**Review of Duke Energy Carolinas, LLC and Duke
Energy Progress, LLC's 2020 Integrated Resource
Plans**

NCUC Docket No. E-100, Sub 165

By: William Powers, P.E.

March 1, 2021

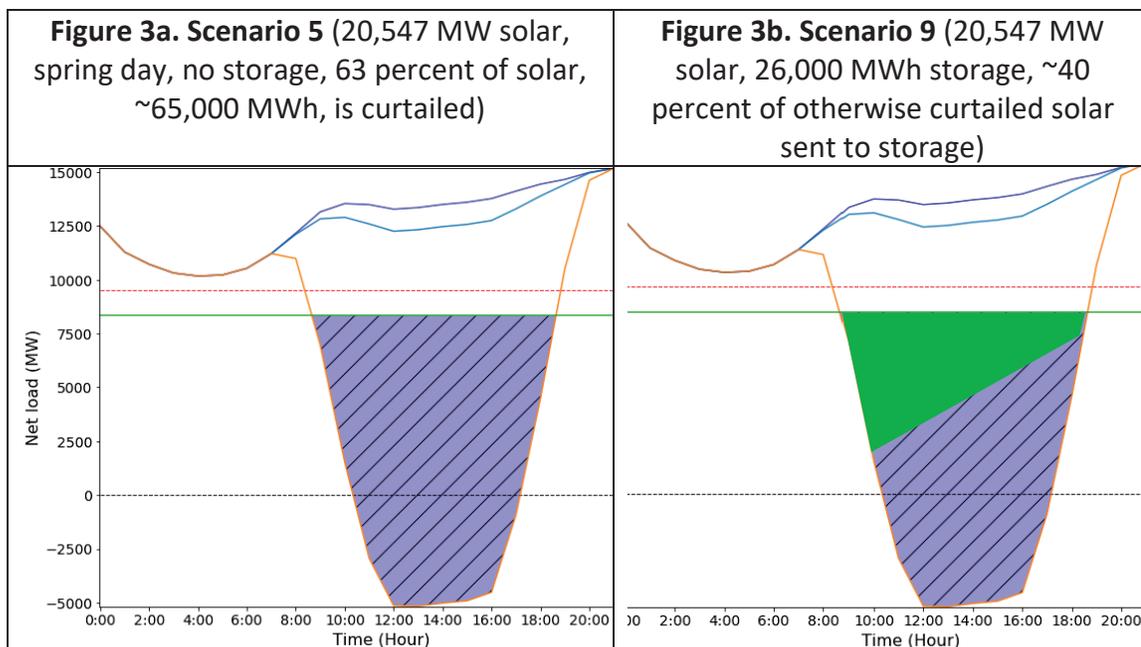
However, only one scenario (Scenario 9) includes battery storage. This is a deficiency in the NREL study. Scenarios 3-7, which include ever higher levels of solar capacity producing ever higher levels of solar power with no place to go without storage, are in effect a form of over-kill. The point is made with Scenario 3.

Scenario 9 misstates the ability of storage to fully absorb the excess solar generation by including far too little storage in the scenario. Scenario 9 matches 20,547 MW of solar with 26,000 MWh of storage.³⁶ In spring and fall, solar will produce 4 to 5 MWh per day per MW of capacity.³⁷ In the case of Scenario 9, the 20,547 MW of solar capacity will produce 80,000 to 100,000 MWh of solar power per day, but there is only 26,000 MWh of storage capacity to absorb this solar output. This means that, solely due to underspecifying the amount of battery storage in Scenario 9, there will be a substantial amount of solar curtailment.

This is shown in Figure 3. The NREL study estimates that on a spring day, with 20,547 MW of installed solar capacity and no additional storage, about 63 percent of that spring day solar production – about 65,000 MWh³⁸ – would have to be curtailed. If 26,000 MWh of storage is added, consistent with Scenario 9, 40 percent of this 65,000 MWh of solar power would be directed to storage, while the other 60 percent would be curtailed. This is shown in Figure 3b, where 40 percent of the otherwise curtailed solar power is directed to storage (green fill).

Figure 4. Modified Scenario 9 with an increase of storage capacity to 65,000 MWh (all solar power that would otherwise be curtailed is directed to storage)

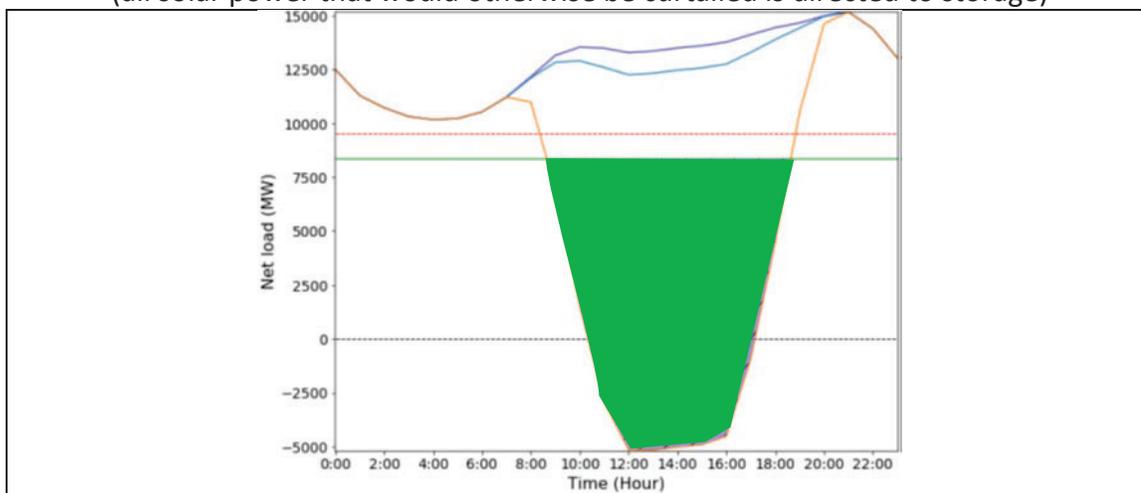
What is missing from the NREL study is the scenario that increases battery storage capacity consistent with the amount of solar capacity to eliminate, or nearly eliminate, solar power curtailments under light load spring and fall day conditions. For example, if Scenario 9 was modified to increase the amount of storage to 65,000 MWh, then the amount of solar curtailment in Scenario 9 would be reduced to zero as shown in Figure 4.
